ORDINANCE NO. 5089

AN ORDINANCE APPROVING A LANDSCAPE PLAN AND STREET TREE PLAN FOR THE BAKER CREEK NORTH SUBDIVISION

DECISION, CONDITIONS, FINDINGS OF FACT AND CONCLUSIONARY FINDINGS FOR THE APPROVAL OF A LANDSCAPE PLAN AND STREET TREE PLAN FOR THE BAKER CREEK NORTH SUBDIVISION

DOCKET: L 12-19 (Tree Removal, Landscape Plan and Street Tree Plan)

Figure 4. Proposed Street Tree Plan

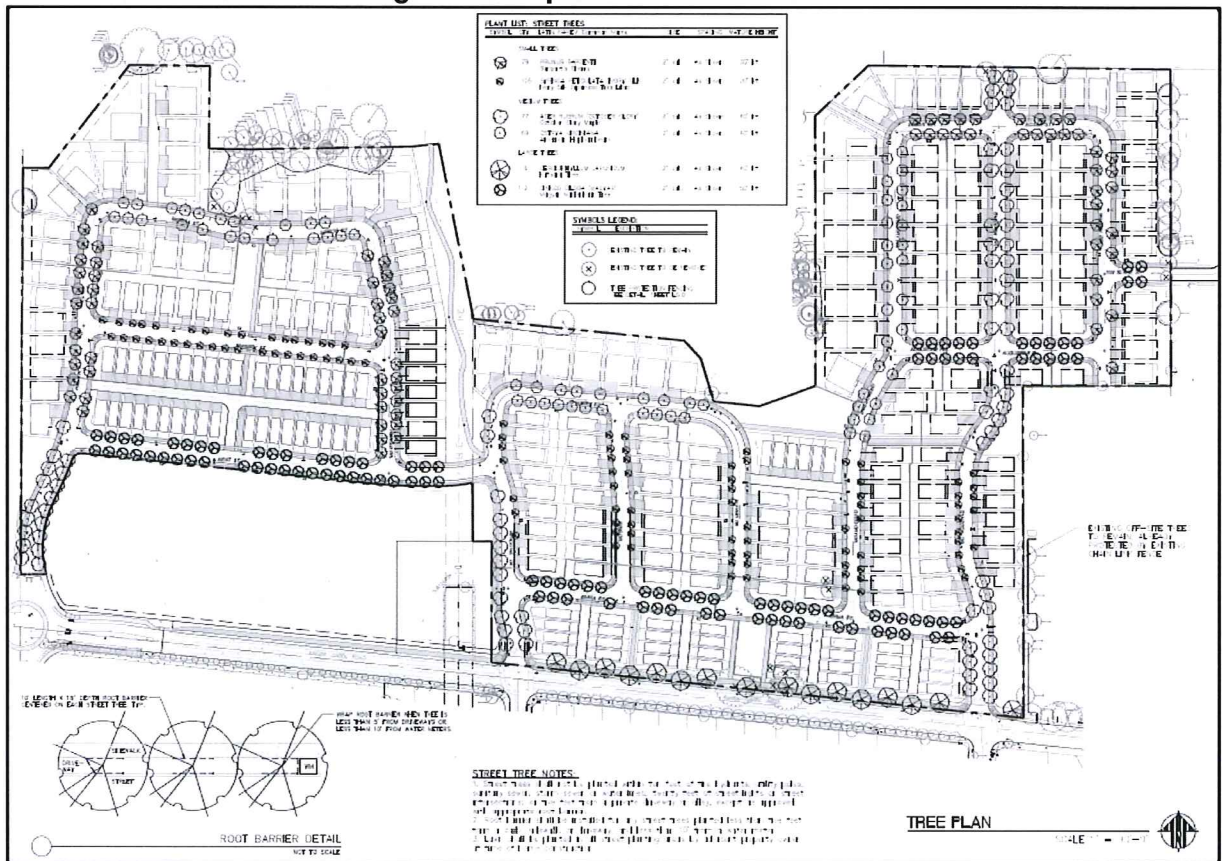
- 8) Street Trees: Street tree spacing varies from the standards of the code as shown on the drawing L1.0 Street Tree Plan. In higher density developments lot frontage decreases and frequency of driveways and utilities increase, creating conflicts that require greater spacing between street trees than outlined in the code. The planned development compensates for the increase in spacing in the following ways.

- Recognizing that street tree plans are reviewed and approved at a later date by the Planning Department and the Landscape Review Committee, we did note that several of the proposed tree locations will need to be adjusted due to probable conflicts with utilities and due to street sight distance concerns.

5. That only the 17 existing trees identified for removal on Drawing L1.0 Street Tree Plan shall be approved for removal.
 6. That landscaping be provided for Sewage Pump Station Tract 'G'. Landscaping shall be provided at an amount equal to or greater than 25 percent of the gross area of the tract, and shall provide screening of the pump station structure from surrounding properties.

- iv. *Ostrya virginiana* (American Hophornbeam)
 - v. *Prunus sargentii* (Sargent Cherry)
15. That street trees in addition to those shown on the Street Tree Plan dated 11/18/2019 shall be provided in the following locations, unless a utility is present that creates a setback requirement:

Pump Station 'Tract G':

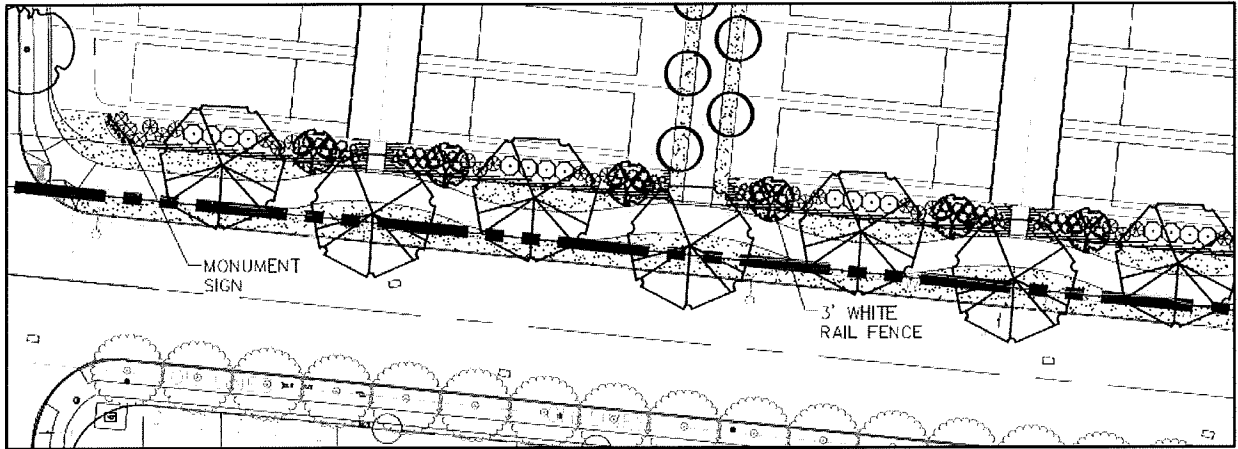
Landscaping was not proposed for Tract G at the intersection of Charles Street and Alfred Drive, where a sewer pump station is located. Tract G is adjacent to residential lots 60, 109, and 110, and is across the street from lots 49, 111, and Open Space Tract F. There is no screening or buffering of the pump station from the adjacent residential uses. A condition of approval requiring landscaping to screen and buffer the sewage pump station has been included.

CONDITION FOR FINDING: That landscaping be provided for Sewage Pump Station Tract 'G'. Landscaping shall be provided at an amount equal to or greater than 25 percent of the gross area of the tract, and shall provide screening of the pump station from surrounding properties.

Open Space 'Tract I':

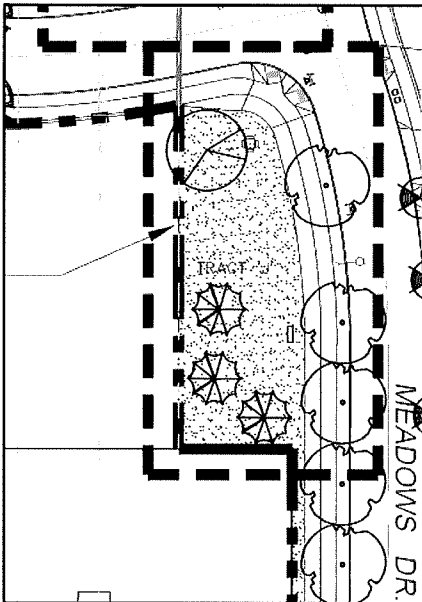
Based on comments from McMinnville Water & Light, trees surrounding the electric substation should be limited in height to 25 feet. A condition is included limiting the height of any trees located in Open Space Tract I to a maximum mature canopy height of 25 feet.

Open Space 'Tract J':

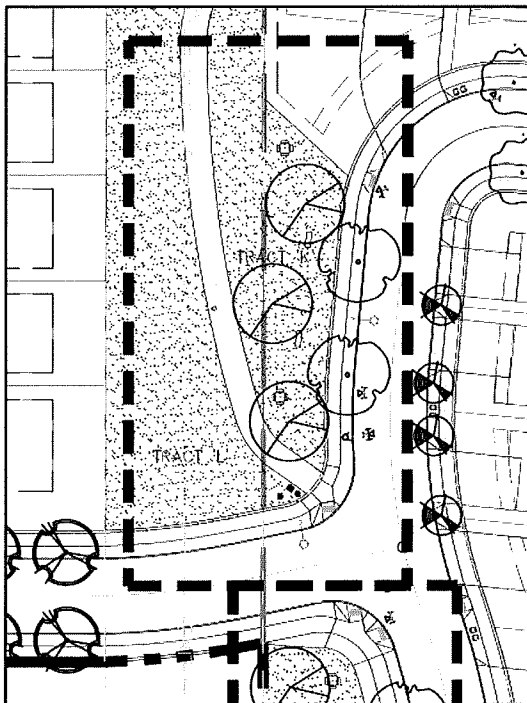
Douglas Fir trees can grow to approximately 100 feet tall and 30 feet wide, and Sunburst Honey Locust grow to approximately 40 feet tall and wide. Based on comments from McMinnville Water & Light, trees surrounding the electric substation should be limited in height to 25 feet. Additionally, trees adjacent to the transmission easement should be limited in height 40 feet and located such that no canopy encroaches into the transmission easement. A condition is included limiting the height of any trees in Open Space Tract J adjacent to the electric substation to a maximum mature canopy height of 25 feet, and no tree in Tract J shall

exceed a maximum mature canopy height of 40 feet or be located such that no canopy encroaches into the transmission easement.

Open Space 'Tract K':

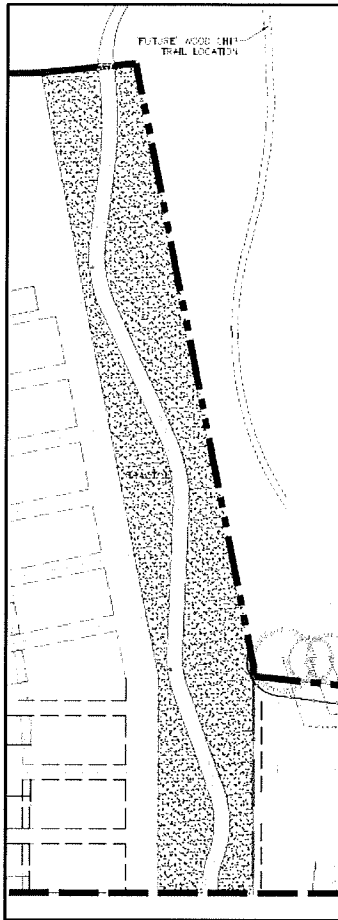
Sunburst Honey Locusts grow approximately 40 feet tall and wide. Based on comments from McMinnville Water & Light, trees in Tract K should be located such that no canopy encroaches into the transmission easement. A condition is included limiting the height of any trees in Open Space Tract K to a maximum mature canopy height of 40 feet and to locations such that no canopy encroaches into the transmission easement.

Open Space & Access Easement 'Tract L':

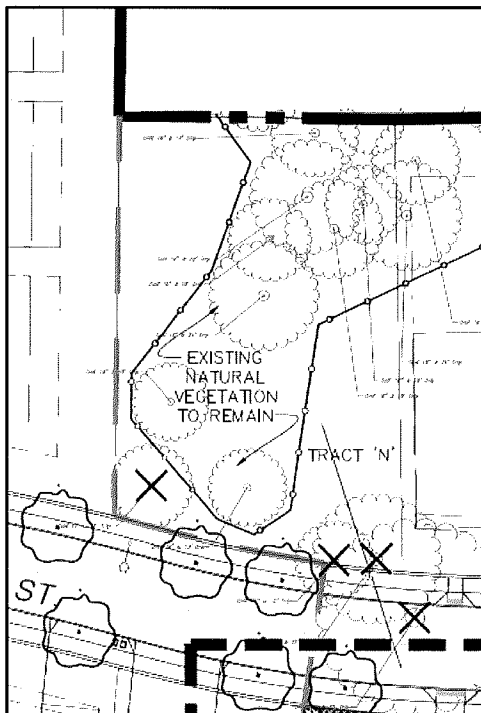
Additionally, no street trees should be located within the public right-of-way in the transmission line easement, where they would be in incompatible with electrical transmission lines overhead.
